# PAINT BRUSH HILLS FILING 14 RELIMINARY PLAN

## PAINT BRUSH HILLS FILING 14 PRELIMINARY PLAN

## 08/24/2020 EPC SUBMITTAL

# Prelim Plan\_v1\_redlines.pdf Markup Summary

PROJECT: PAINT BRUSH HILLS FILING NO. 14  
 PRELIMINARY GRADING AND EROSION CONTROL PLAN  
 PROJECT NO. 10-014  
 PREPARED BY: CIVIL CONSULTANTS, INC.  
 DATE: 8-12-20  
 SCALE: 1" = 100'  
 SHEET: 4 OF 5  
 PGEC1

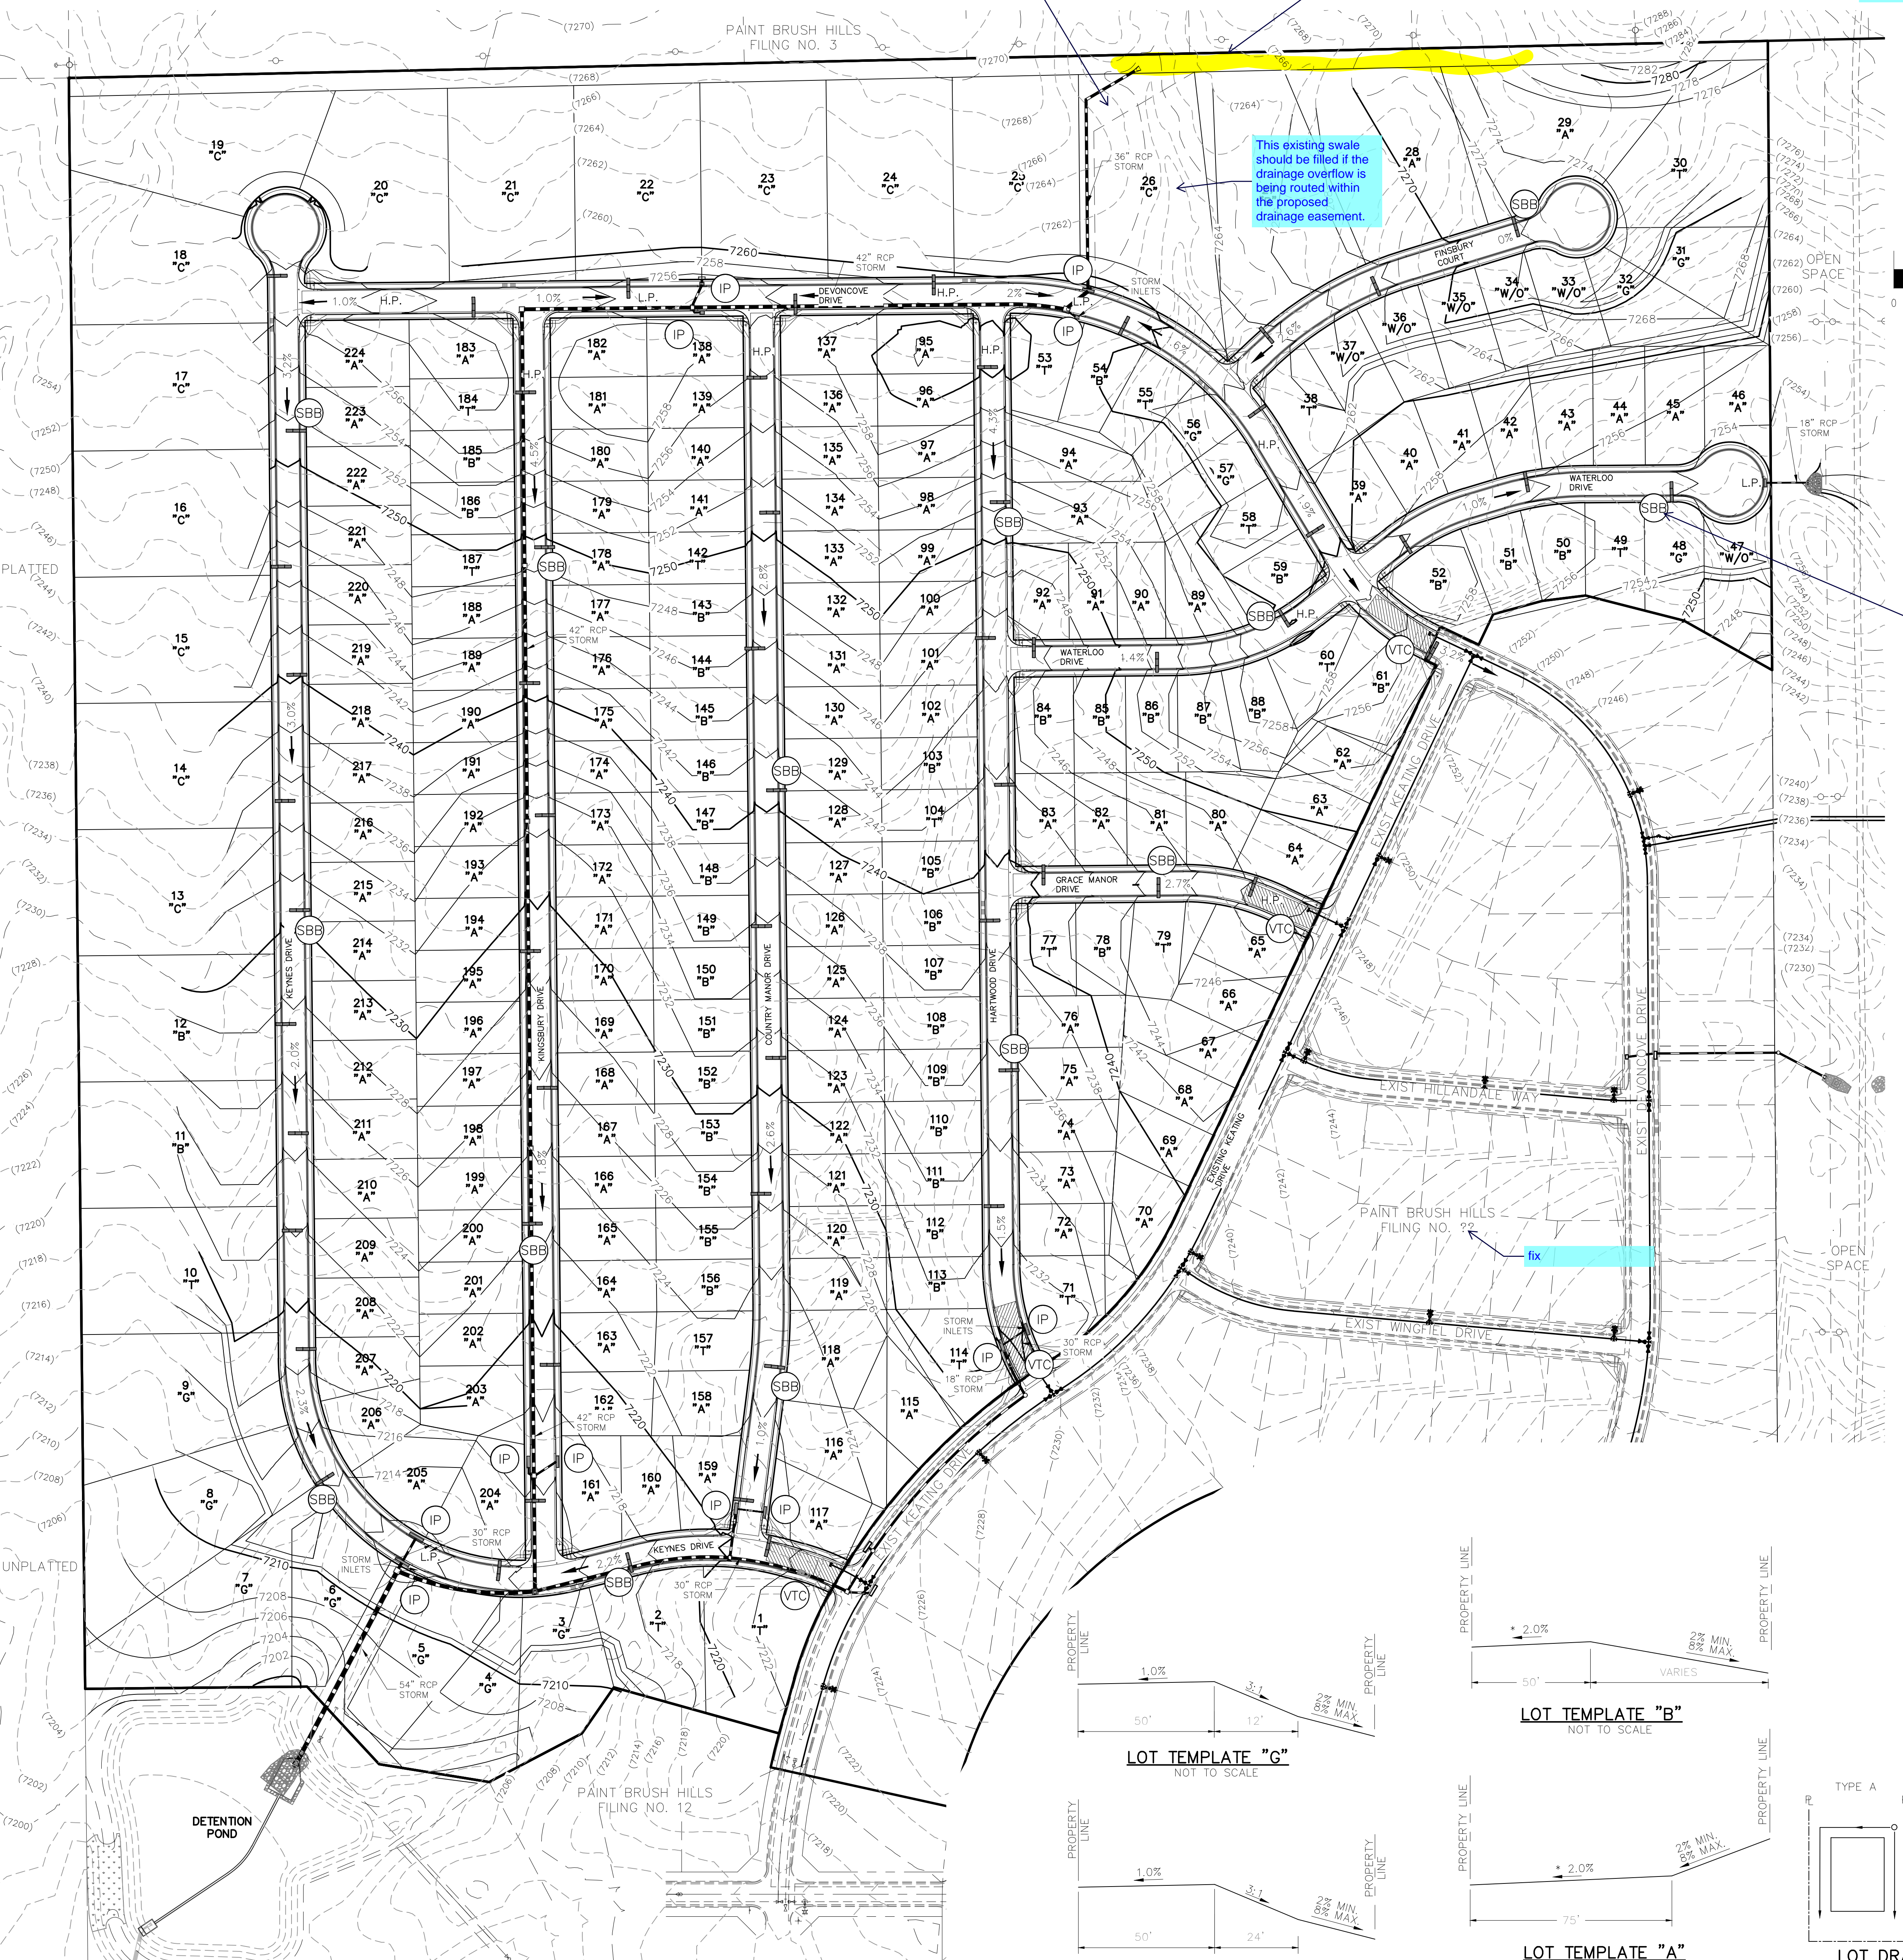
Based on the drainage report this drainage easement which also contains a drainage swale, therefore must include a restriction for no build and no storage of materials. Also update the final plat document to reflect the restriction.

Provide/Show maintenance access to the drainage swale and FES. A looped path or turnaround would need to be provided.

This existing swale should be filled if the drainage overflow is being routed within the proposed drainage easement.

Remove notes.

Remove temporary BMPs on the preliminary grading plan.

Revise title to Preliminary Grading Plan

PAINT BRUSH HILLS FILING NO. 14  
 PRELIM UTILITY & PUBLIC FACILITY PLAN  
 PROJECT NO. 10-014 FILE: \\WAY\COLERA\SUBFILES\10014-1014.dwg  
 DESIGNED BY: DM DATE: 8-12-20  
 DRAWN BY: JG SCALE: 1"=100'  
 CHECKED BY: VAS SHEET 5 OF 5  
 PLOT1

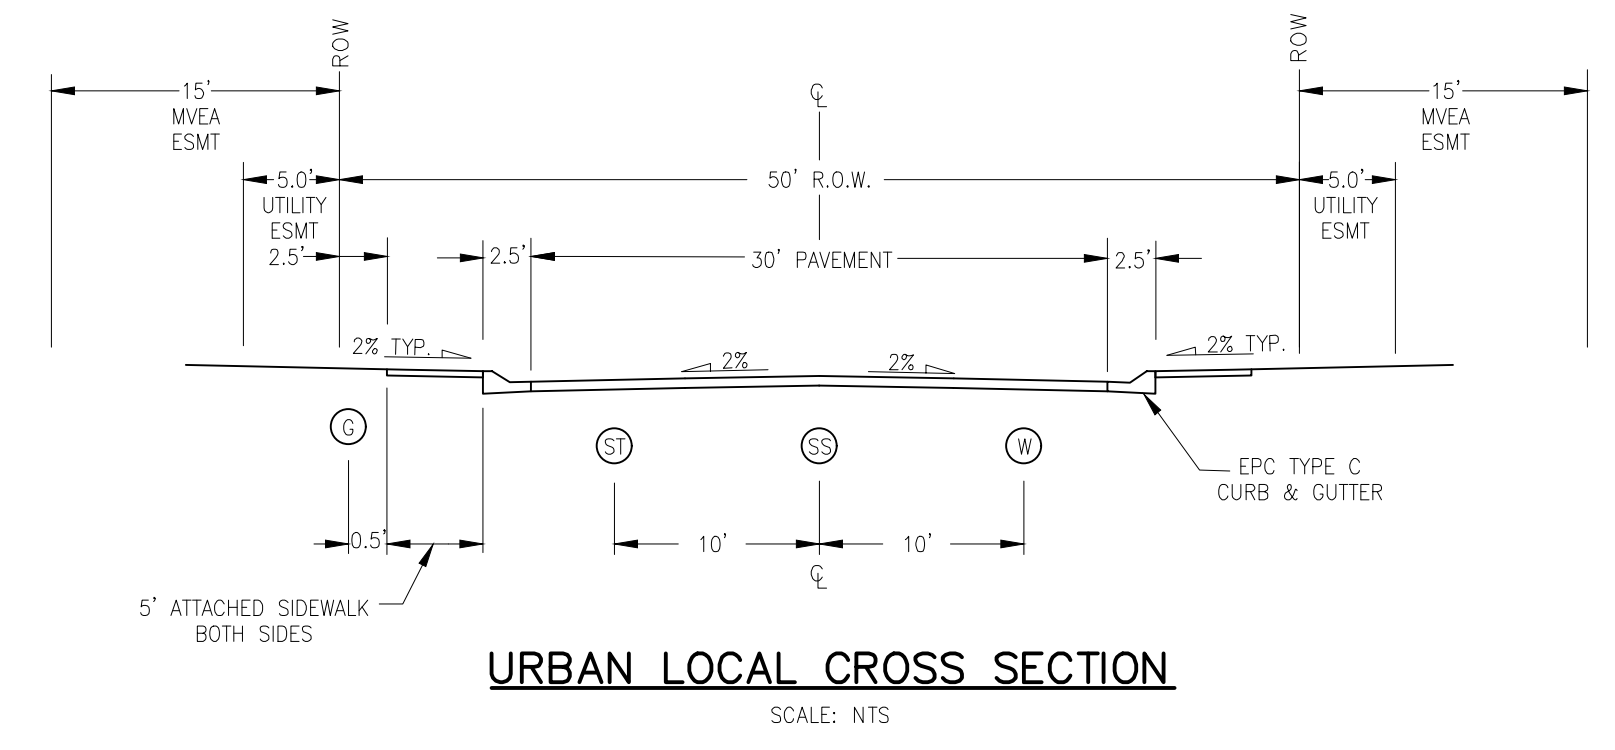
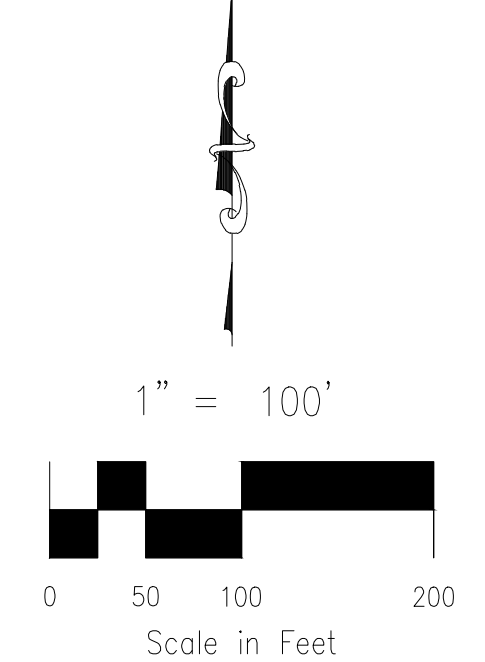
**Subject:** Callout  
**Page Label:** [1] PUT Revise stormdrain layout to be within the road asphalt  
**Author:** dsdlaforce  
**Date:** 11/2/2020 11:14:22 AM  
**Status:**  
**Color:** ■  
**Layer:**  
**Space:**
